URBAN DESIGN COMMITTEE

AGENDA

2. [Lincoln-Lancaster County Public Building Commission Parking Garage Expansion -UDR25041](#) – *Advisory Review*
3. [Tallgrass Development Façade Improvement – University Garage Parking Building -UDR25088](#) – *Advisory Review*

APPLICATION NUMBER Urban Design Record #UDR25041

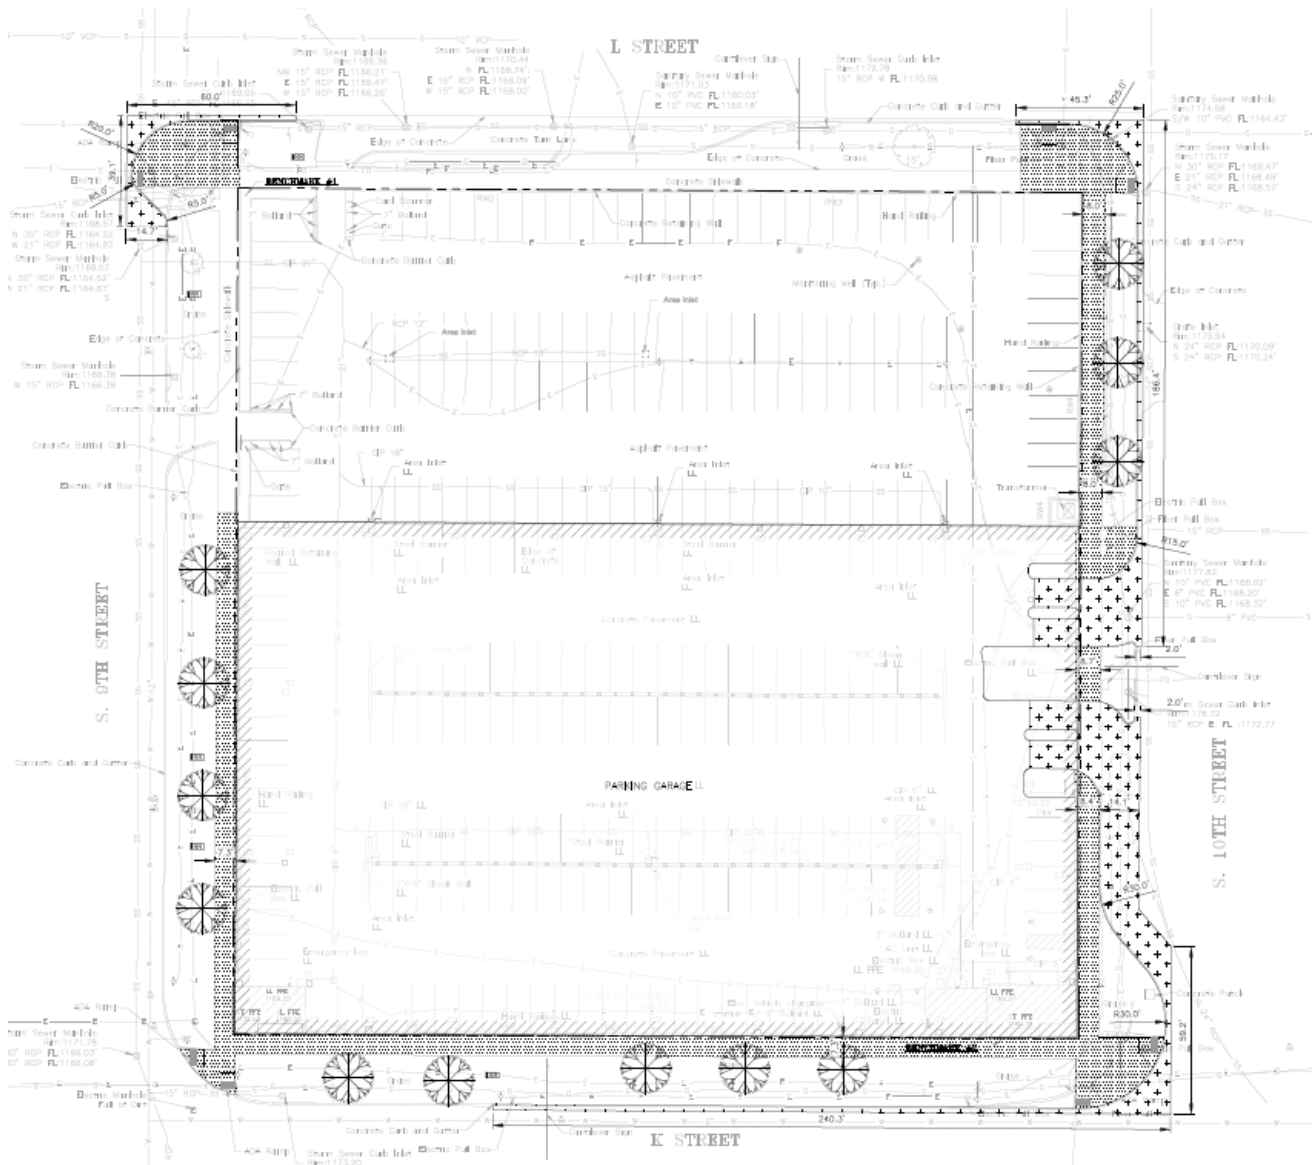
At the time, the City (Planning, LTU, and Urban Development) was of the opinion that the design of the entrances/exits on 10th Street is of concern as the vehicle movements would have a crisscross conflict point in the access lane.

The City had the following comments after reviewing the plan:

- Remove dual lane exits on 9th and 10th Streets, and minimize the weaving conditions. Creating a weaving operation is not advised on such a busy corridor.
- Eliminate the dual entry from 10th St.
- Maintain single lane exit around midblock, on 10th Street to provide a good blend of internal garage circulation, merging space onto 10th, and offset from K and L.
- Maintain the current single-lane entrance on K Street. This would allow for maximum separation from entrances/exits.
- Consider removing internal stalls to allow for better left-turn movements inside the garage from the K Street entrance.
- Address how the mid-block landscaped beds will be maintained.

In response, Rega submitted a revised plan.

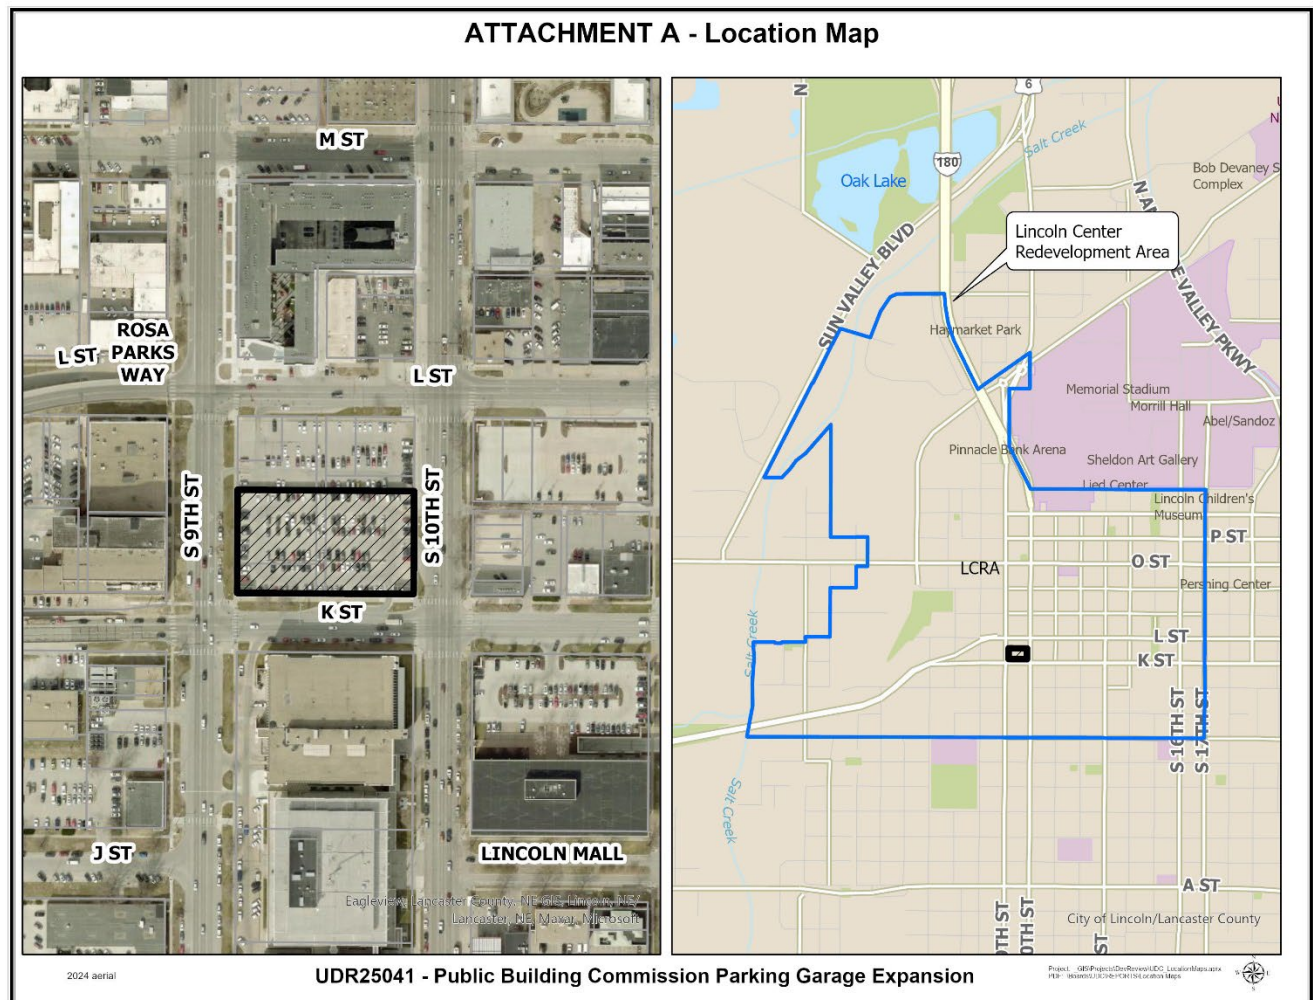
However, the City Staff has been meeting internally as well as with the design team to address some unresolved issues, such as

1. Elimination of dual entry on 10th St, and keeping one exit on 10th St.
2. Absence of entry from K St.
3. How the changes in entry and exits influence the elevations of the Parking building.

1. The 'K' Street entrance has been eliminated to reduce potential for traffic conflict at the new exit inside the garage and decrease Traffic/Pedestrian conflicts outside of the garage, and
2. PBC would not be able to maintain the landscaping for the project. They are exploring additional options for the maintenance of the landscaping. City staff is in conversation with DLA regarding the landscape maintenance. No decision has been made yet.

SITE LAYOUT PLAN

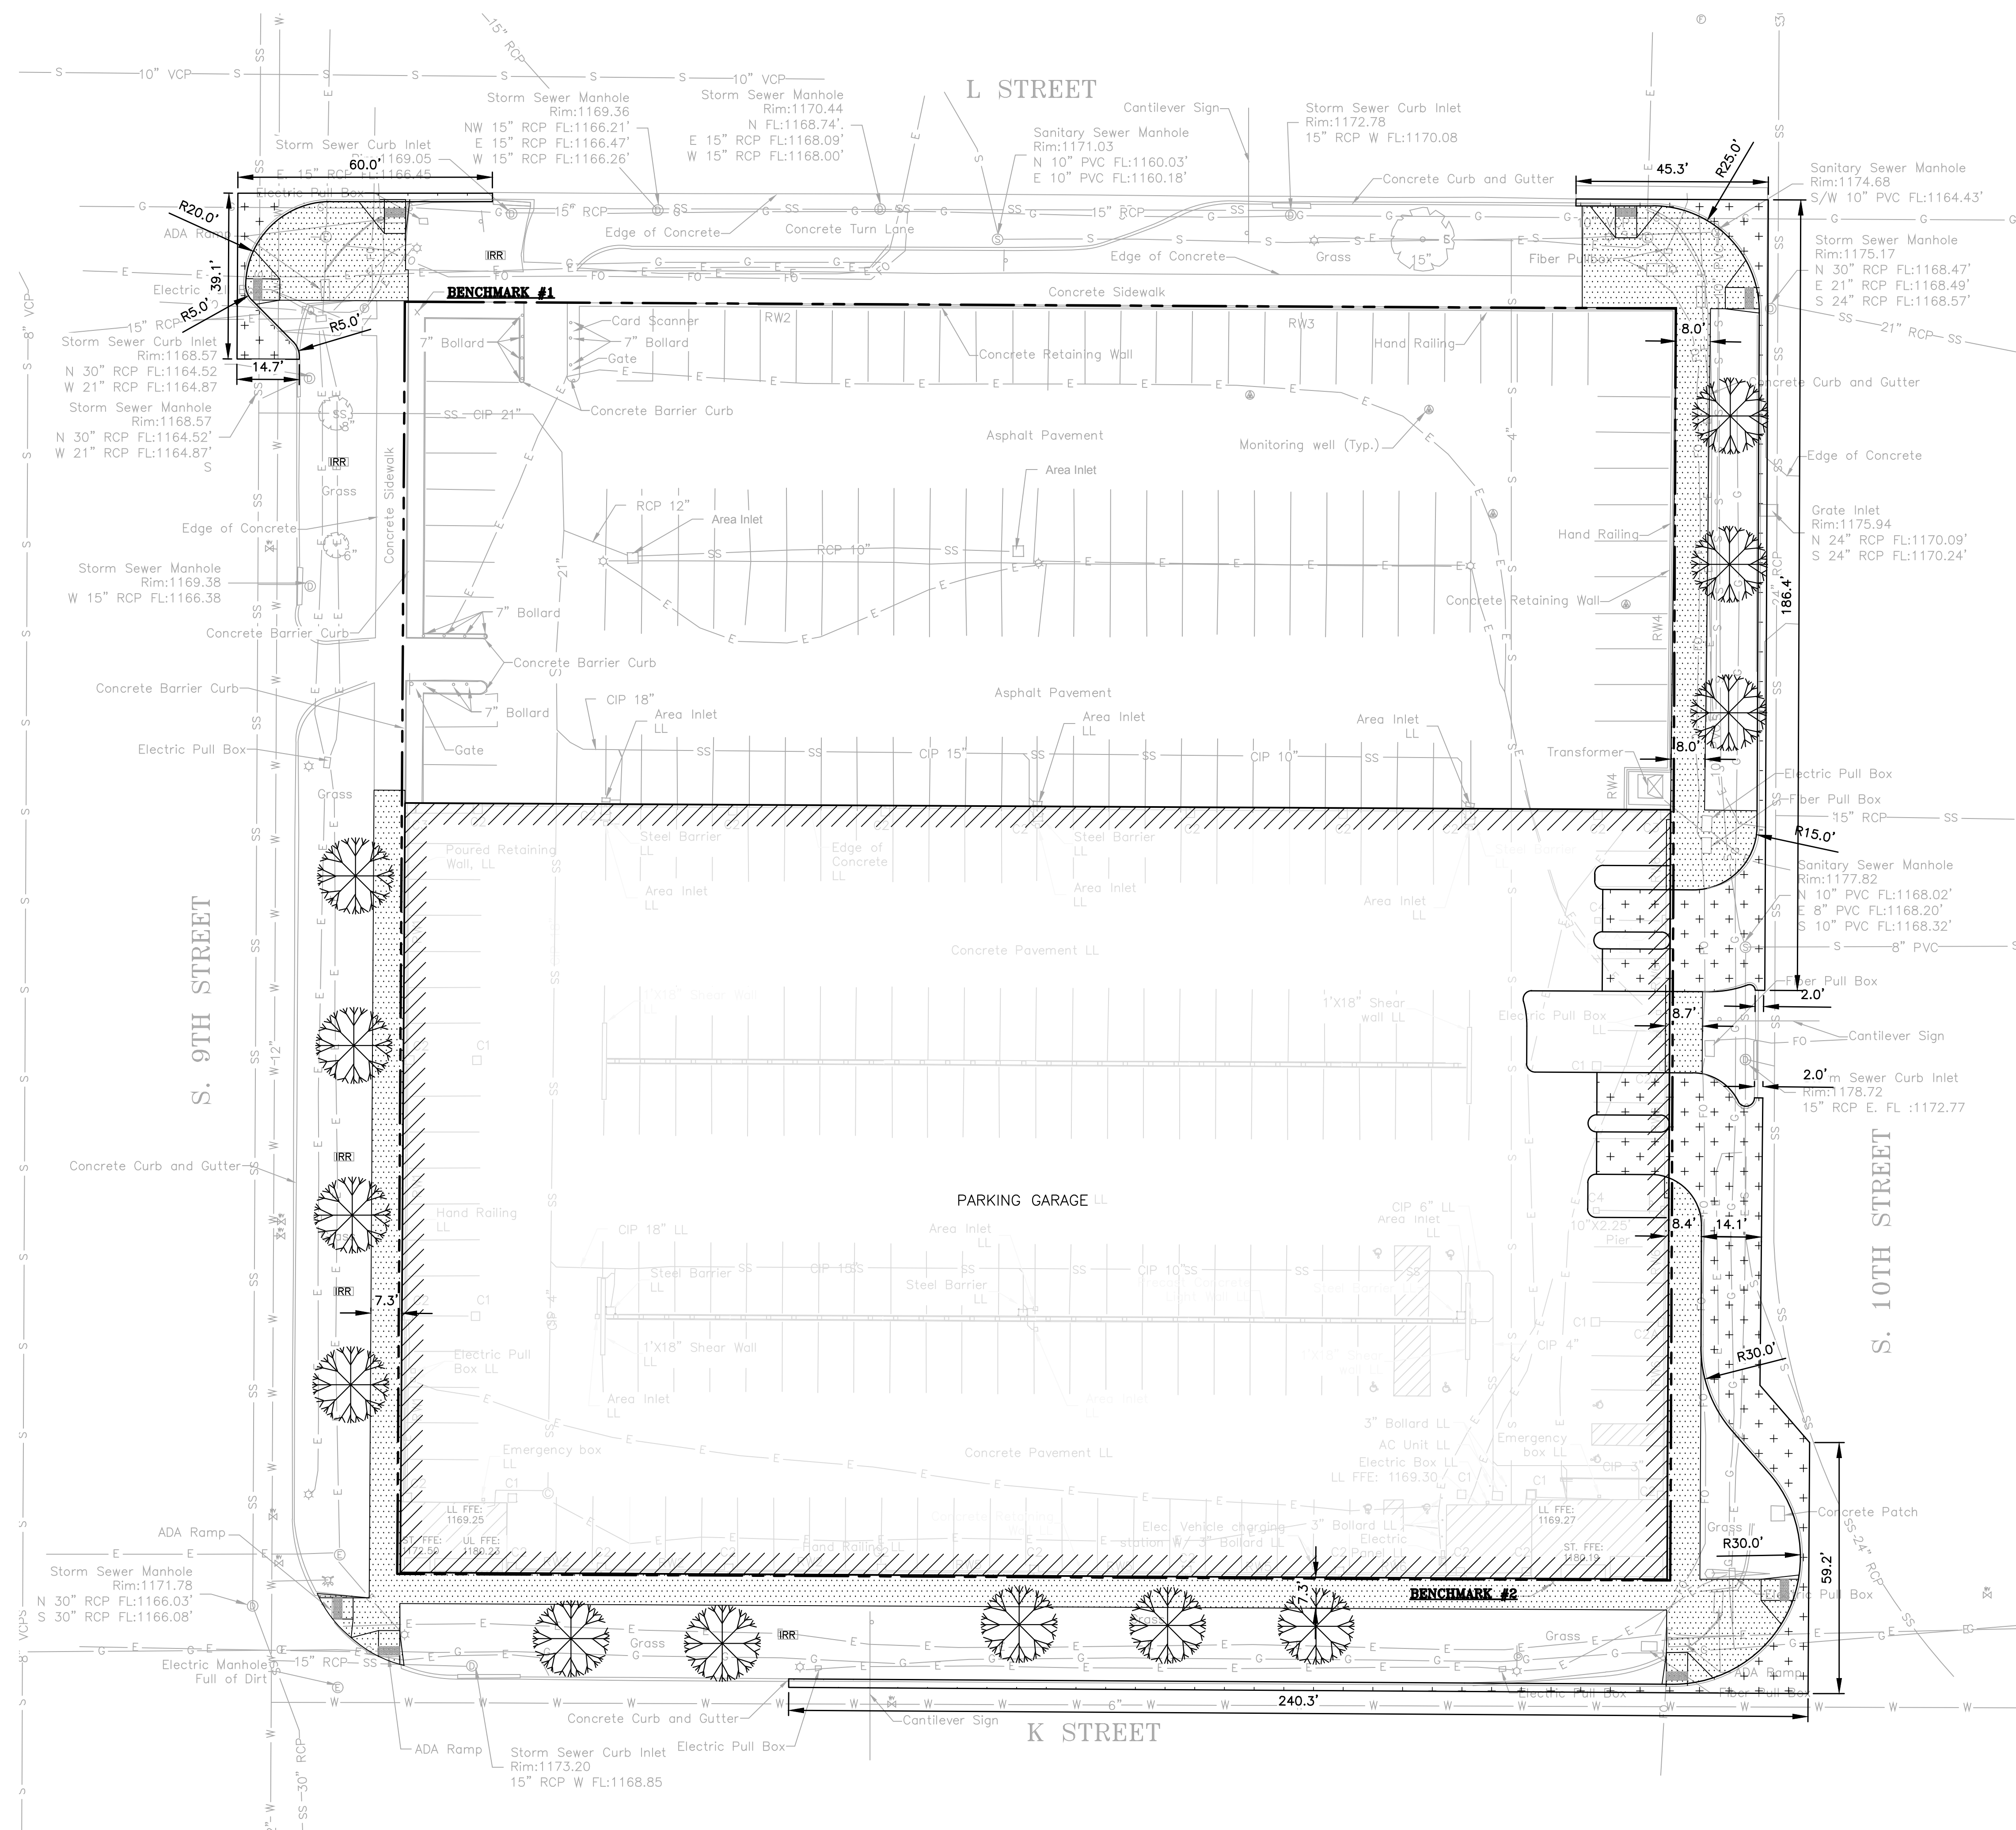
The Urban Design Committee's input is being sought on the revised site plan and proposed vehicular circulation, particularly regarding their effects on the surrounding street network.
